Management Assessment of Alternative Methods for Exploratory
Shaft Construction/Testing Sequences and
Additional Exploratory Drifting

September 1989

Prepared by the U.S. Department of Energy in Response to
Suggestions from the Structural Geology and Geoengineering
Panel of the Nuclear Waste Technical Review Board

FIGURE 1

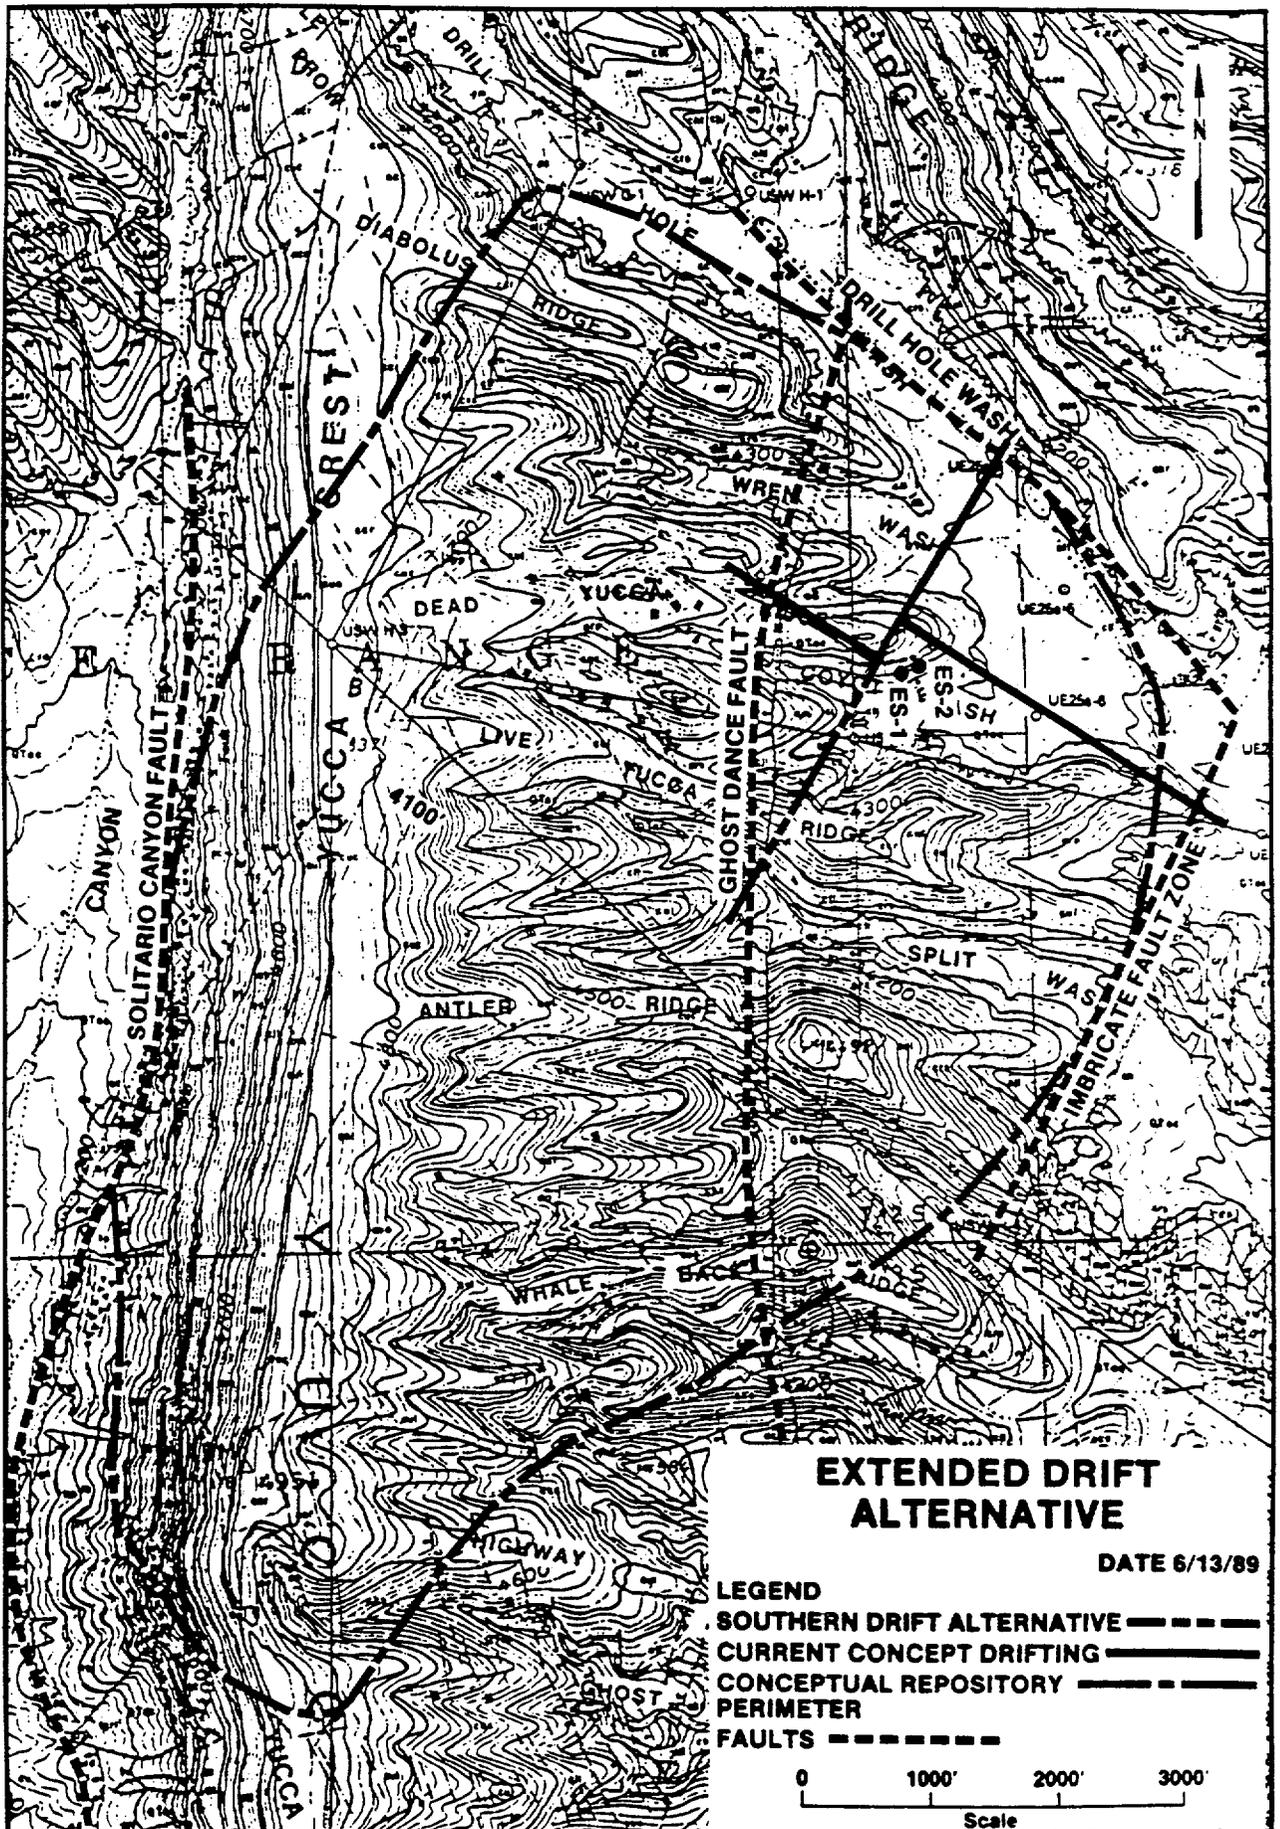
Consider expanding the currently planned exploratory drifting to the Ghost Dance Fault to include an exploratory drift to the south to intersect the fault at additional locations where the offset appears to be significant.

The principal purpose for drifting to the Ghost Dance fault (Figure 1) is to obtain hydrologic and structural data for performance assessment and repository design. The hydrologic characteristics of this major fault zone which transects the proposed repository block are particularly important to the modeling of site ground-water flow paths and travel times. Ground-water flux through the host rock is expected to be negligible and fault or fracture zones could represent preferential pathways for such flow. Although the currently planned intersection with the Ghost Dance fault is believed to offer a reasonable opportunity for obtaining representative hydrologic data for the fault zone, there is some indication on the surface that the Ghost Dance fault may be a hinged fault with increased displacement to the south. The magnitude of this offset, important for repository design, and potentially associated hydrologic variability have yet to be established.

Since displacement apparently increases to the south, a southern intersection (e.g., approximately midway between the currently planned

intersection and boreholes UZ-7 and UZ-8) may be more representative of the hydrologic and structural conditions at the MTL, and would provide added confidence to the characterization of this structure.

- Several lines of closely spaced surface-based boreholes across the Ghost Dance fault, which could include inclined boreholes, and detailed surface mapping along the fault, should be considered to obtain additional information on fault characteristics and stratigraphic offset.
- The addition of an exploratory drift to the south for a second intersect with the Ghost Dance fault offers sufficient additional benefits relative to costs to warrant its inclusion in the exploratory drifting plans.
- If only one exploratory drift is driven to the Ghost Dance fault, it should be an exploratory drift to the south rather than the currently planned exploratory drift to the northwest.

FIGURE 6-1

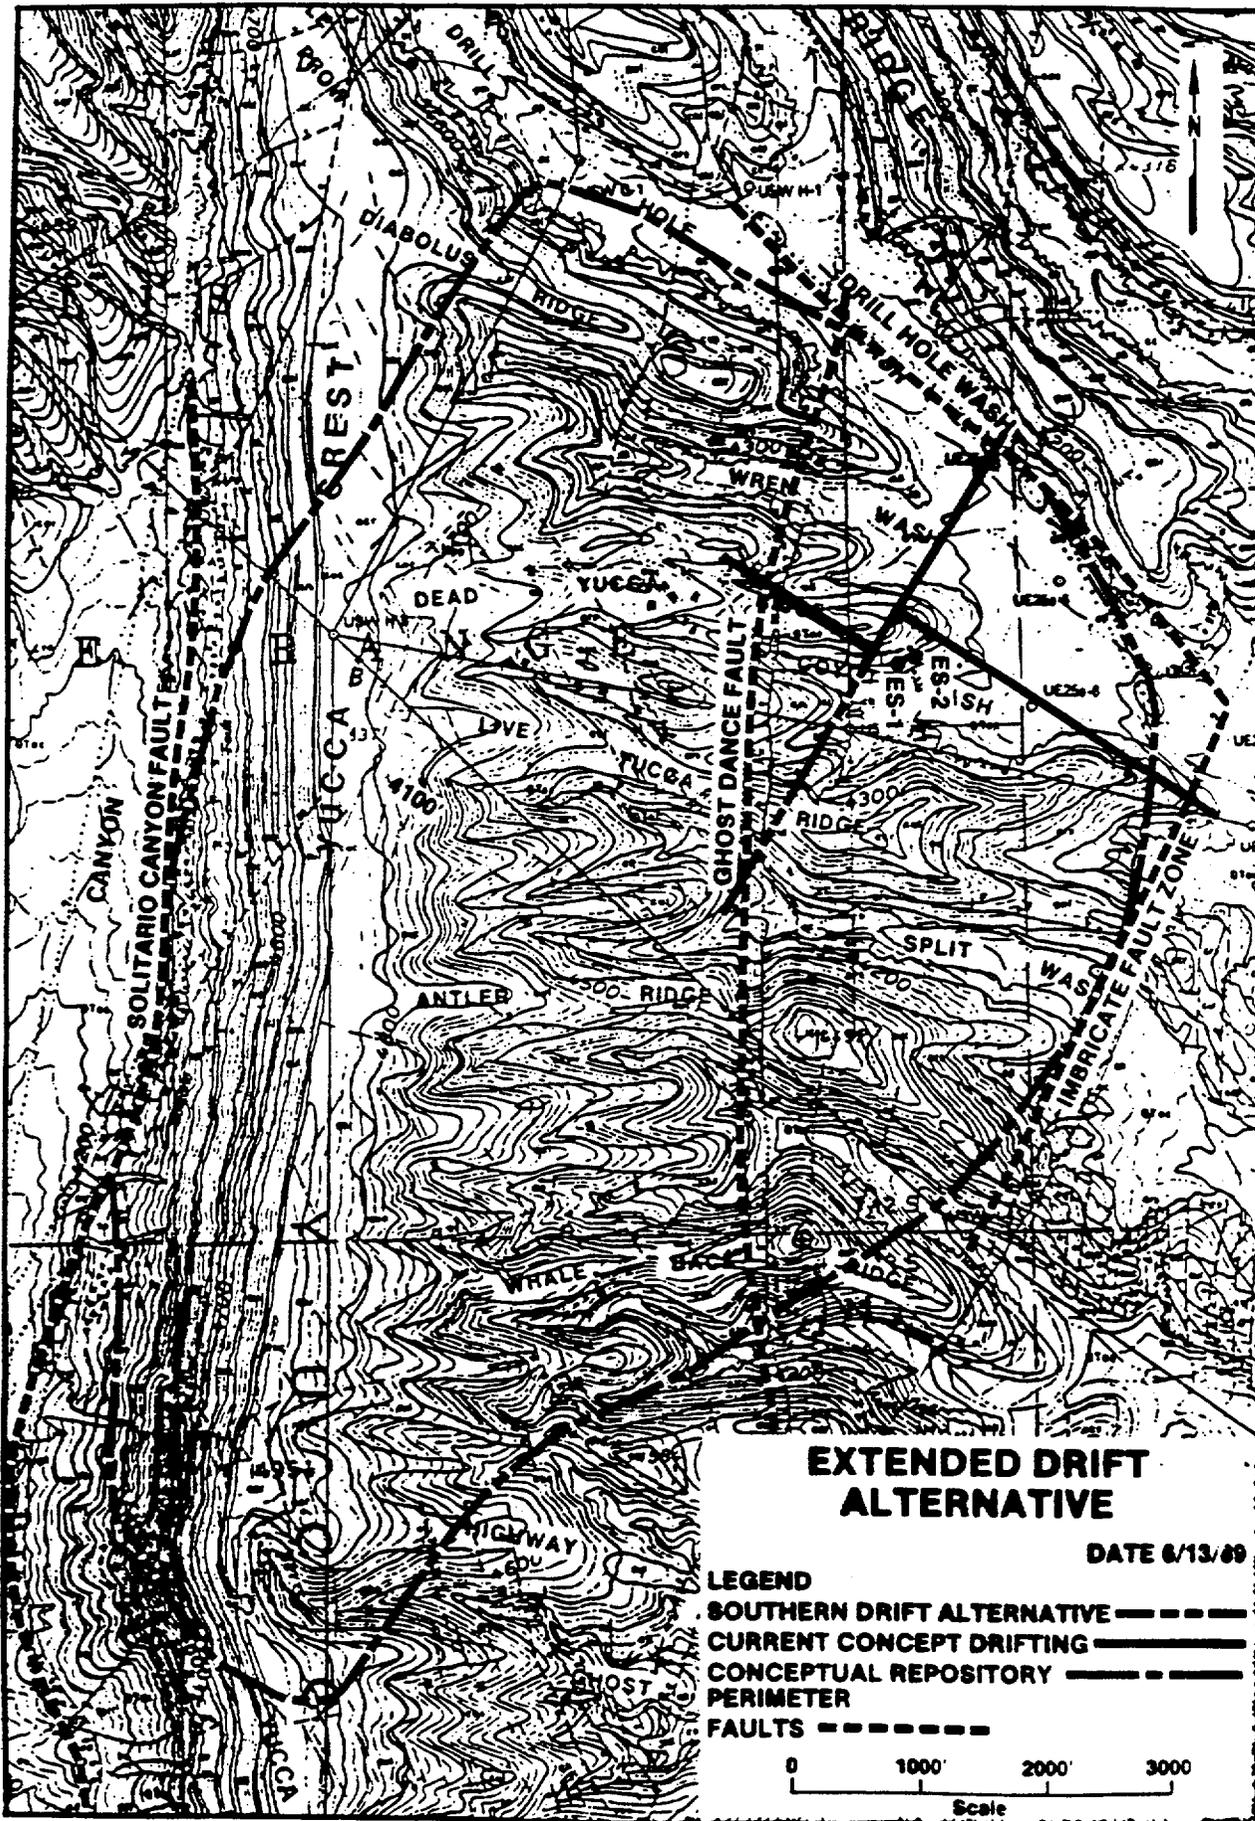
- It appears that an extended exploratory drift can be excavated without a significant adverse impact to the program schedule;
- The extended exploratory drift to the Ghost Dance fault (Figure 6-1) will reduce uncertainty regarding structural and hydrologic characteristics along the southern portion of the fault;

FIGURE 8-1

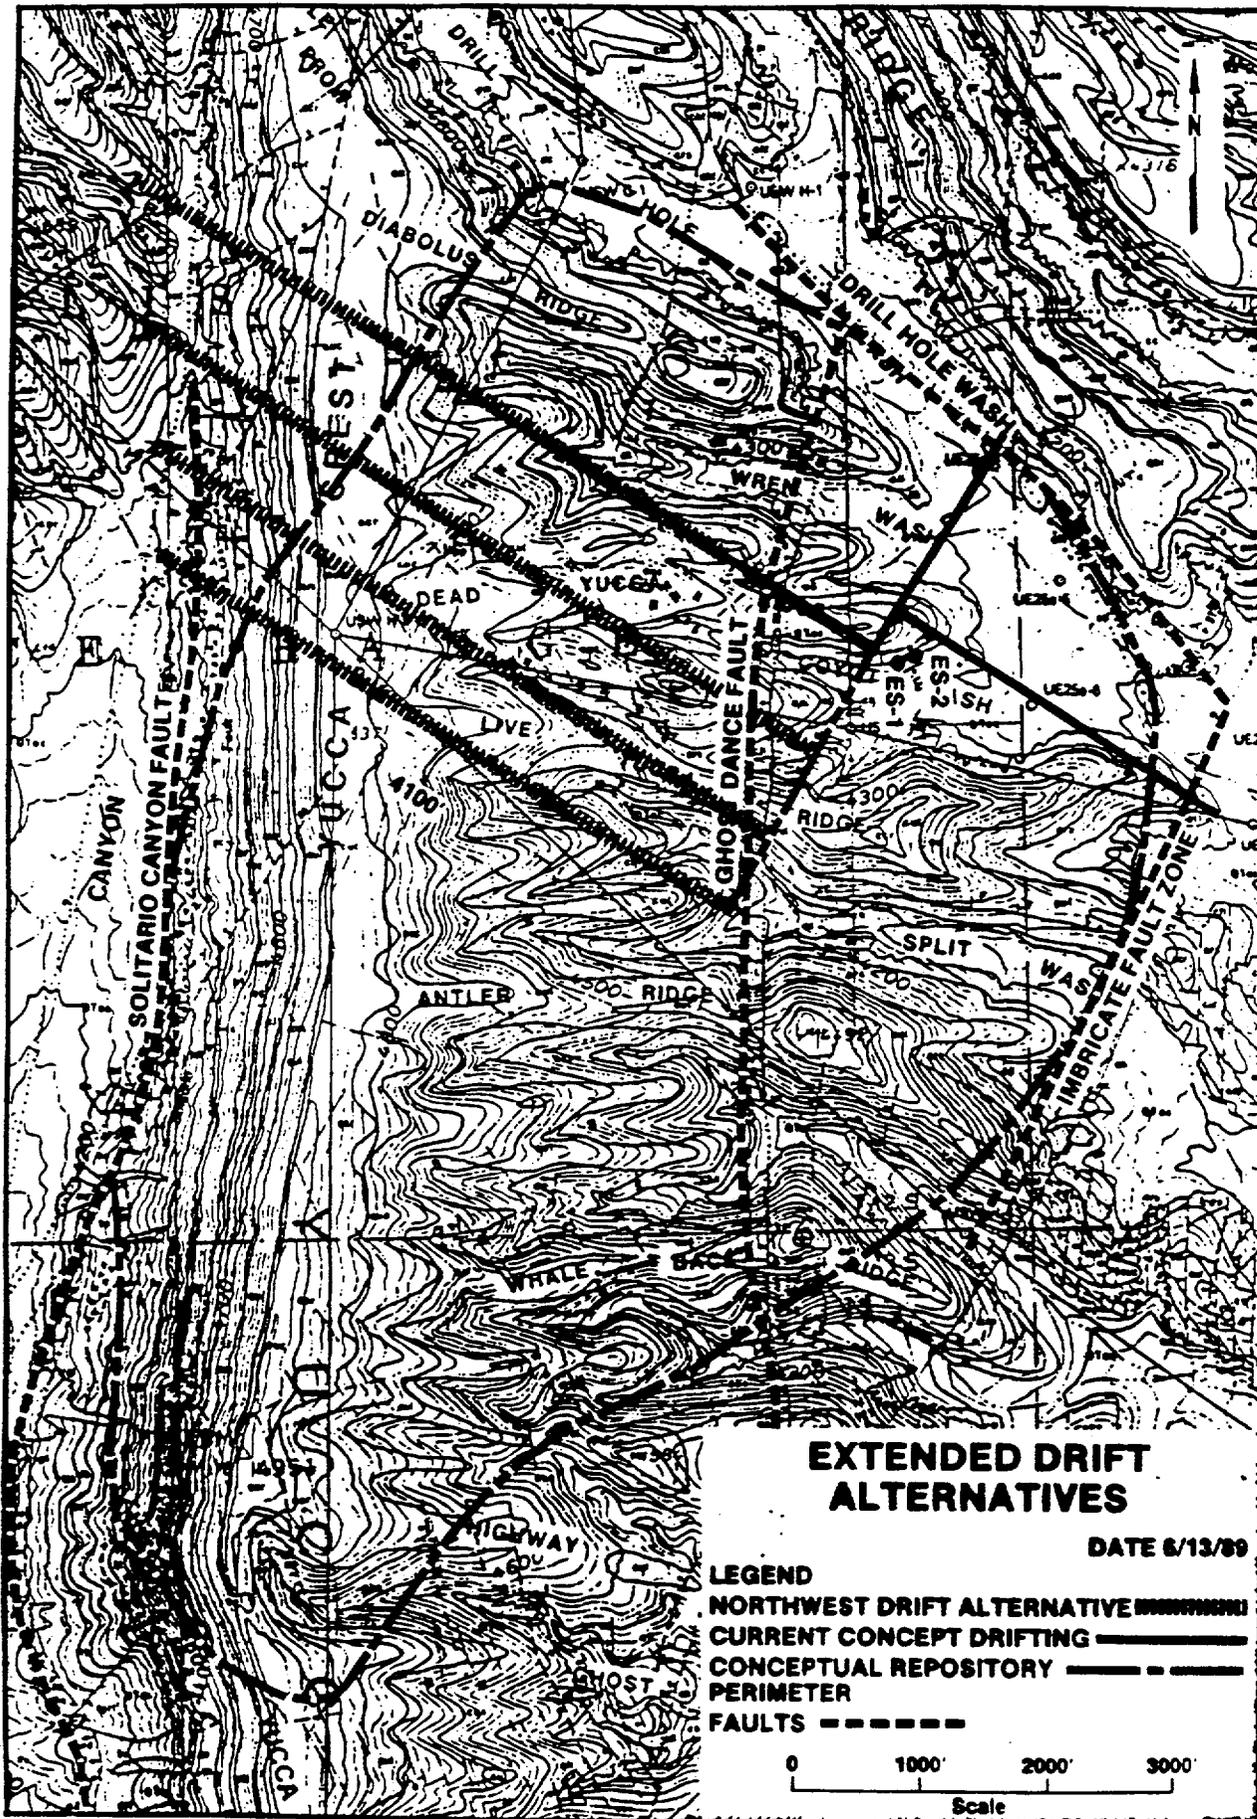
- Depending on the location of the feature(s) of concern, an additional exploratory drift approximately 4,100 feet long could be located coincident with one of several proposed panel access drifts (Fig. 8-1) in the conceptual underground repository layout. The location and grade of an appropriate panel access drift is less likely to change after new site data have been incorporated into repository design.
